APPLICATION NO.	FILING DATE	FIRST NAMED INVENTOR	ATTORNEY DOCKET NO.	CONFIRMATION NO.
10/572,894	03/20/2006	Ian David Stones	M03B354	1336
71134	7590	06/10/2010	EXAMINER	
Edwards Vacuum, Inc. 2041 MISSION COLLEGE BOULEVARD SUITE 260 SANTA CLARA, CA 95054			BOBISH, CHRISTOPHER S	
			ART UNIT	PAPER NUMBER
			3746	
			NOTIFICATION DATE	DELIVERY MODE
			06/10/2010	ELECTRONIC

Office Action Summary	Application No.	Applicant(s)
	10/572,894	STONES ET AL.
	Examiner	Art Unit
	CHRISTOPHER BOBISH	3746

DETAILED ACTION

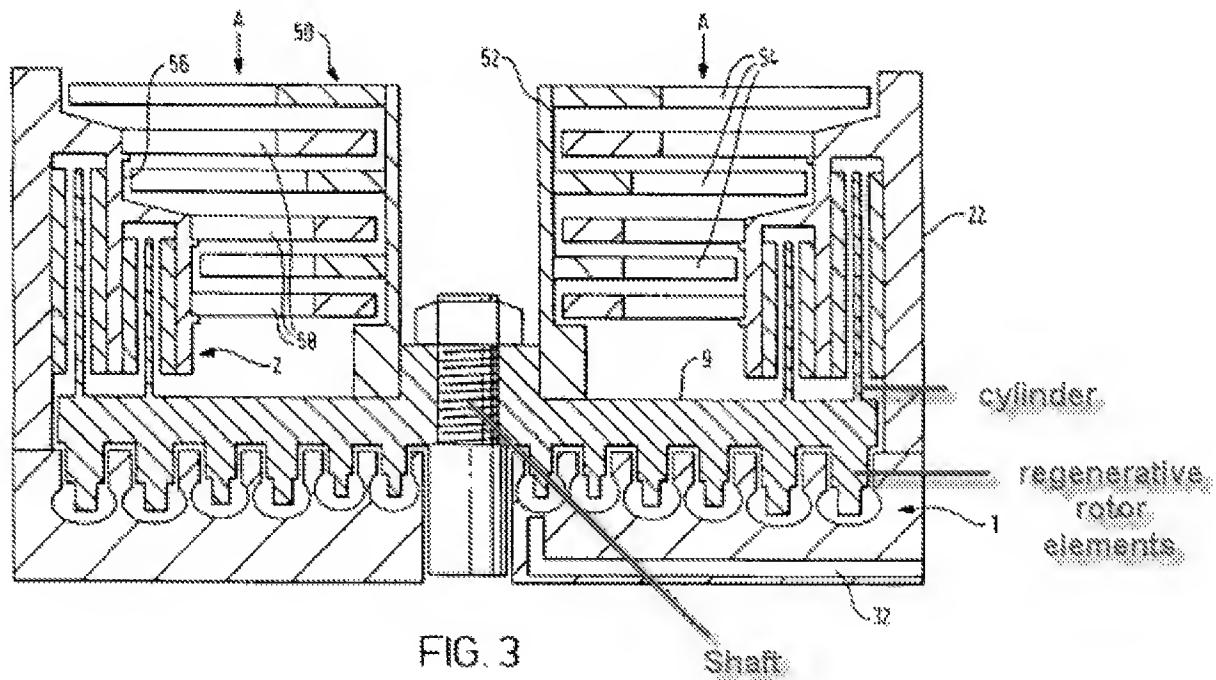
a vacuum pump, **FIG. 3 C. 1 Line 4**, comprising a molecular drag pumping mechanism, **FIG. 3 (2) C. 3 Line 43 (Holweck)**, and, downstream therefrom, a regenerative pumping mechanism, **FIG. 3 (1) C. 3 Line 45**; wherein the rotor element of the molecular drag pumping mechanism comprises a cylinder mounted for rotary movement with the rotor elements of the regenerative pumping mechanism, **FIG. 3 (1) C. 3 Line 45, FIG. 3 shown below and adapted by the examiner shows a cylinder of the molecular drag section (Holweck) attached to a rotor (9) of the regenerative section (1)**; Stones further teaches in **FIG. 1** that the cylinder of the drag section is also known to be a separate part from the rotor (see 9 and 26), one of ordinary skill would find it obvious to substitute one known coupling technique for another based on assembly requirements;

limitations from claim 4, a pump, wherein the rotor element of the molecular drag pumping mechanism, **shown and labeled by examiner in the above drawing**, and the rotor elements, **shown and labeled by examiner in the above drawing**, of the regenerative pumping mechanism, **FIG. 3 (1) C. 3 Line 45**, are located on a common rotor, **FIG. 3 (9) C. 3 Line 24**, of the pump;

limitations from claim 5, a pump comprising an impeller, **FIG. 3 (52) C. 3 Line 25 (rotor body)**, mounted on a drive shaft of the pump, the rotor being integral with the impeller, **the impeller (52) is mounted on the rotor (9) which is mounted on a shaft (shown and labeled by examiner in the above drawing)**;

limitations from claim 7, a pump, wherein the rotor elements of the regenerative pumping mechanism comprise a series of blades, **shown and labeled in above drawing as regenerative rotor elements**, **C. 3 Lines 5-7** examiner considers “rings” to be equivalent to “blades”, positioned in an annular array on one side of the rotor;

limitations from claim 10, a pump, wherein the regenerative pumping mechanism, **FIG. 3 (1)**, comprises at least two series of blades, **shown and labeled in above drawing as regenerative rotor elements**, **C. 3 Line 5**, positioned in concentric annular arrays on said one said of the rotor **FIG. 3 (9)**;

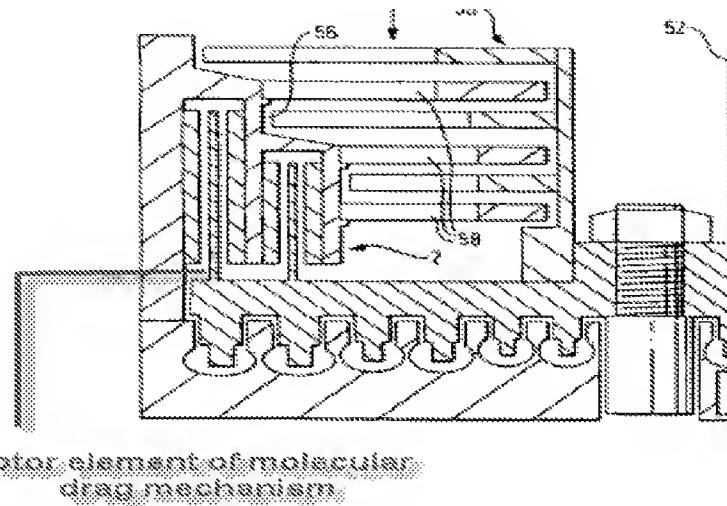
limitations from claim 26, a pump, wherein the rotor element of the additional pumping mechanism, **FIG. 3 (50)**, is integral with the impeller, **C. 3 Lines 25-29**, **it can be seen from FIG. 3 that the elements (54) are integral with impeller (52);.**

FIG. 3

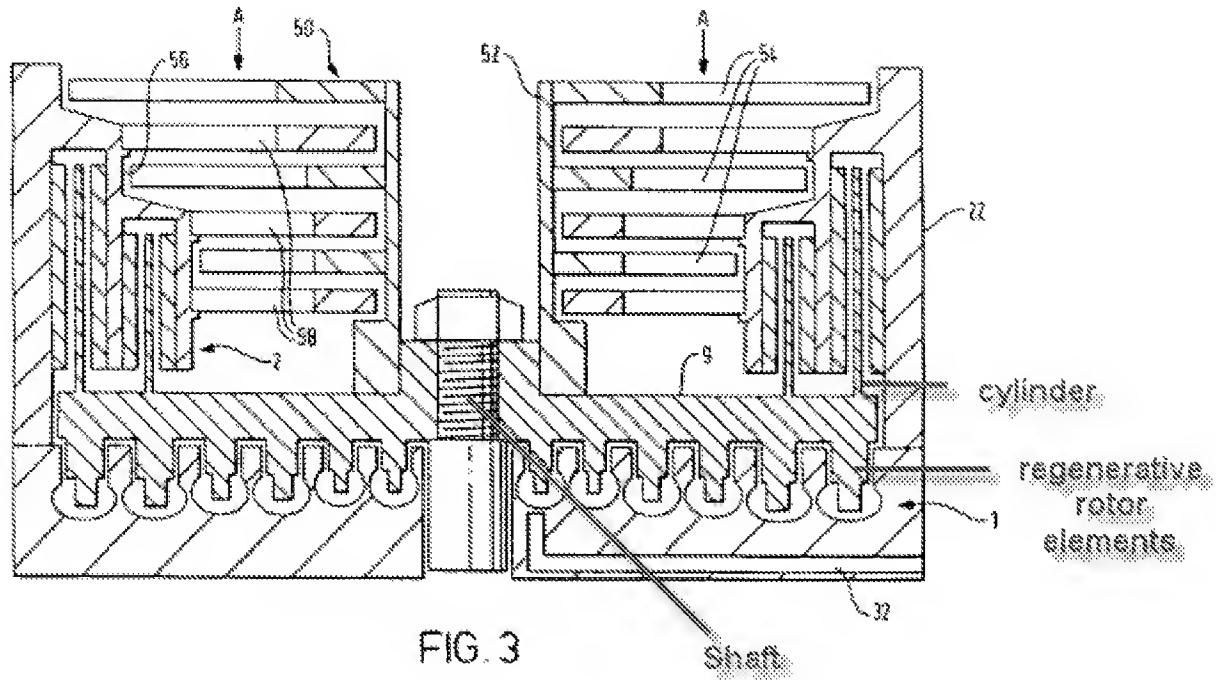
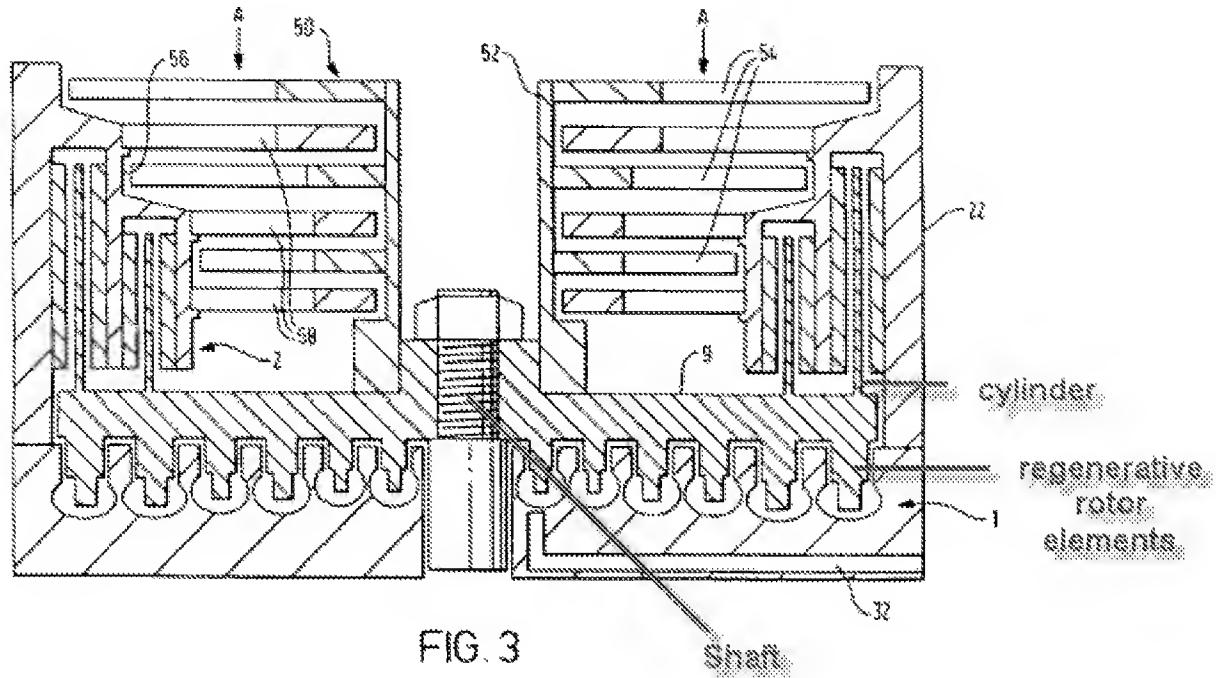
limitations from claim 29, an impeller, **FIG. 3 (52, 9) C. 3 Lines 24-25 (rotor body (52) and rotor (9) are considered by examiner to comprise an impeller)**, for a vacuum pump, **FIG. 3 C. 1 Line 4**, the impeller comprising a rotor element, **FIG. 3 is shown below and is adapted to show the rotor element extending from impeller (52, 9)**, of a molecular drag pumping mechanism, **FIG. 3 (2)**, and a plurality of rotor elements, **shown and labeled by examiner in the above drawing, extending from impeller (52, 9)**, of a regenerative pumping mechanism, **FIG. 3 (1)**; wherein the rotor element of the molecular drag pumping mechanism comprises a cylinder mounted for rotary movement with the rotor elements of the regenerative pumping mechanism, **FIG. 3 (1) C. 3 Line 45, FIG. 3 shown below and adapted by the examiner shows a cylinder of the molecular drag section (Holweck) attached to a rotor (9) of the regenerative section (1)**; Stones further teaches in **FIG. 1** that the cylinder of the drag section is also known to be a separate part from the rotor (see 9 and 26), one of ordinary skill would find it obvious to substitute one known coupling technique for another based on assembly requirements;

rotor element of molecular
drag mechanism

limitations from claim 32, an impeller, FIG. 3 (52, 9) C. 3 Lines 24-25 (rotor body (52) and rotor (9) are considered by examiner to comprise an impeller), wherein the rotor element of the molecular drag pumping mechanism, shown and labeled by examiner in the above drawing (cylinder), and the rotor elements, shown and labeled by examiner in the above drawing, of the regenerative pumping mechanism are located on a common rotor of the impeller, FIG. 3 (9) C. 3 Line 24;

limitations from claim 33, and impeller, FIG. 3 (52, 9) C. 3 Lines 24-25 (rotor body (52) and rotor (9) are considered by examiner to comprise an impeller), these parts appear integral together in the drawing above; wherein the rotor is integral with the impeller;

limitations from claim 36, an impeller, **FIG. 3 (52, 9) C. 3 Lines 24-25 (rotor body (52) and rotor (9) are considered by examiner to comprise an impeller)**, according to claim 35; wherein the blades are integral with the rotor, **the impeller (52, 9) is mounted on the rotor (9) which is mounted on a shaft (shown and labeled by examiner in the above drawing)**;

limitations from claim 42, a vacuum pump comprising a molecular drag pumping mechanism and a regenerative pumping mechanism, a drive shaft, **(shown and labeled by examiner in the above drawing)**, having located thereon a rotor element for the molecular drag pumping mechanism and rotor elements for the regenerative pumping mechanism; **FIG. 3 shown below and adapted by the examiner shows a cylinder (rotor element) of the molecular drag section (Holweck) attached to a rotor (9) of the regenerative section (1) attached to a shaft shown below**; wherein the rotor element of the molecular drag pumping mechanism comprises a cylinder mounted for rotary movement with the rotor elements of the regenerative pumping mechanism, **FIG. 3 (1) C. 3 Line 45, FIG. 3 shown below and adapted by the examiner shows a cylinder of the molecular drag section (Holweck) attached to a rotor (9) of the regenerative section (1)**; Stones further teaches in FIG. 1 that the cylinder of the drag section is also known to be a separate part from the rotor (see 9 and 26), one of ordinary skill would find it obvious to substitute one known coupling technique for another based on assembly requirements;

limitations from claim 46, a pump, wherein the rotor element of the molecular drag pumping mechanism, **shown and labeled by examiner in the above drawing (cylinder)**, and the rotor elements, **shown and labeled by examiner in the above drawing**, of the regenerative pumping mechanism are located on a common rotor, **FIG. 3 (9)**, of the pump.

limitations from claim 47, a pump comprising an impeller, **FIG. 3 (52, 9) C. 3 Lines 24-25 (rotor body and rotor is considered by examiner to comprise an impeller)**, mounted on the drive shaft, **shown and labeled by examiner in the above drawing**, and wherein the rotor is integral with the impeller, **FIG. 3 (52, 9) C. 3 Lines 24-25 (rotor body and rotor are considered by examiner to comprise an impeller)**, these parts appear integrally connected;

limitations from claim 48, a pump, wherein the rotor, **FIG. 3 (9)**, comprises a disc, **C. 3 Line 3**, substantially orthogonal to the drive shaft, **shown in above drawing**;
